Detroit
Edison

July 17, 1991
NRC-91-0086

Subject: Station Blackout Rule Implementation

A) Design Calculation Number DC-4986		B) Volume Number I	
C) Revision 0	D) PIS Number R1100	E) QA Level 1M	
F) ASME Code Classification NA		G) Certification Required <input type="checkbox"/> Yes <input checked="" type="checkbox"/> No	
H) Lead Discipline ELECTRICAL		I) Incorporation Code F	
J) Title DEFINITION OF ALTERNATE AC POWER FOR SBO			
K) Revision Summary ORIGINAL CALCULATION

DC 4986
Pg 12 of 29

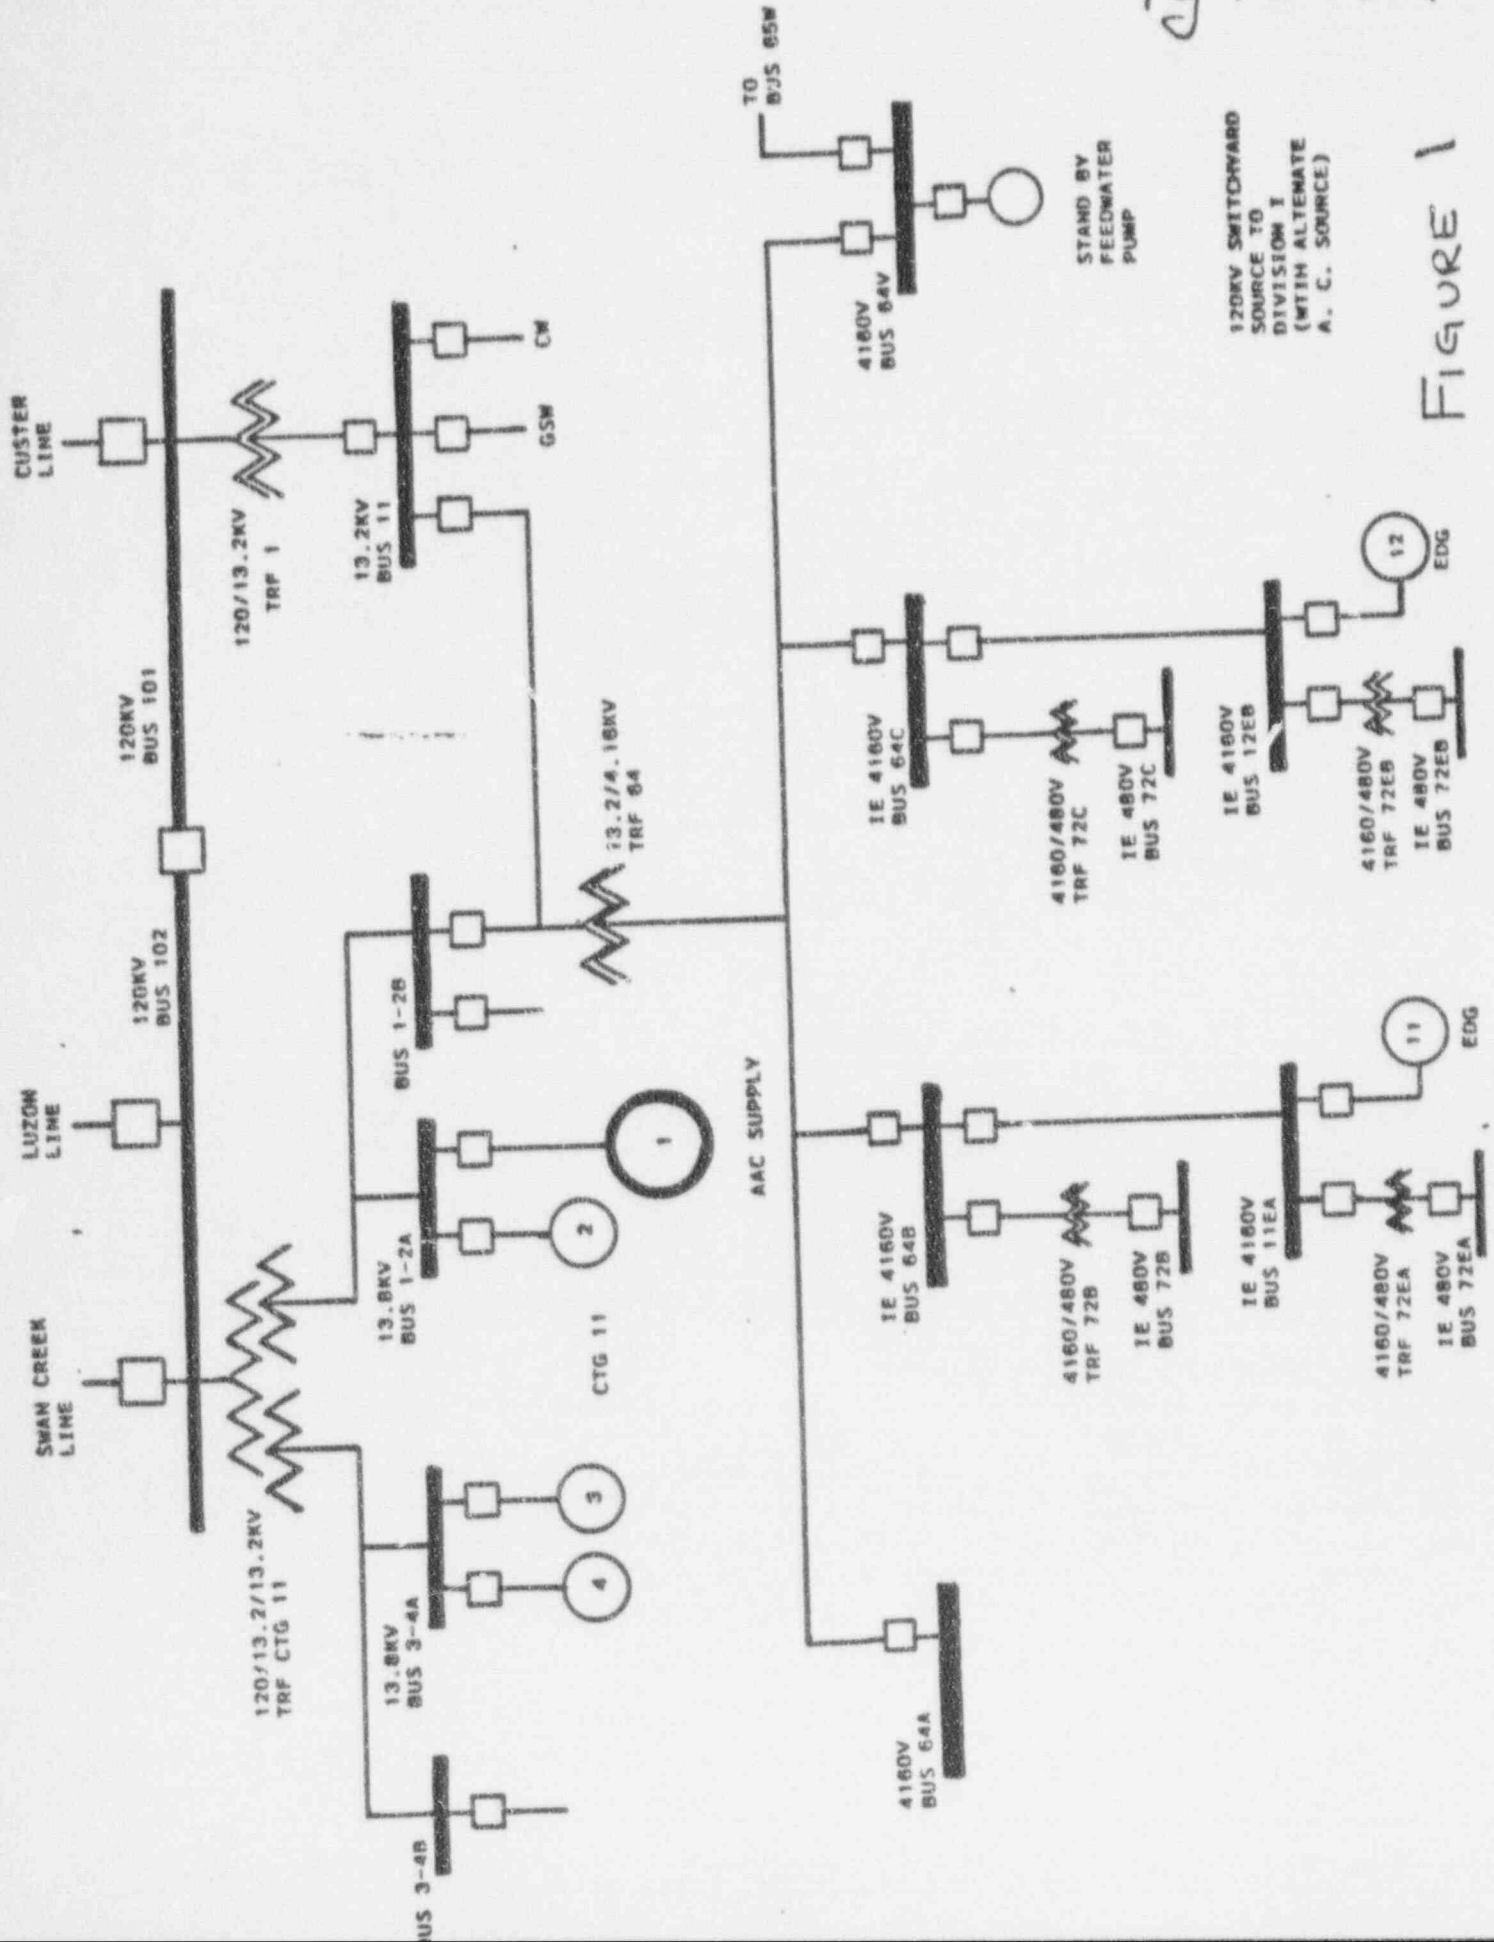
Test the alternate AC source to show that it can be started and connected to the safe shutdown loads within one hour. Describe how the Combustion Turbine Generator meets the criteria of NUMARC 87-00, Appendix B.

volt buses through various system service Transformers [refer to Figure 1 page 12 of SD-2500-1].

120 KV switchyard and is physically separated from the EDG's and all safety related equipment, a failure of the CTG will not adversely affect the Class IE AC power systems. Connection of the unit to the Class IE.

equipment will be by the normal system service transformer 64 feed from the 120KV offsite switchyard not directly to any plant bus (refer to Figure 1 pg 12)

one of which is a class IE breaker. Referring to figure 1 and drawing SD-2500-1 you can note that the following breakers are between the AAC and the Class IE buses:

- Output breaker of the CTG,
- Input breaker to transformer 64.
- Output breaker from transformer 64 to plant IE buses. [B6, C6]

The breakers in the feeds to Buses 64B and 64C are part of that Class IE switchgear and are class IE breakers
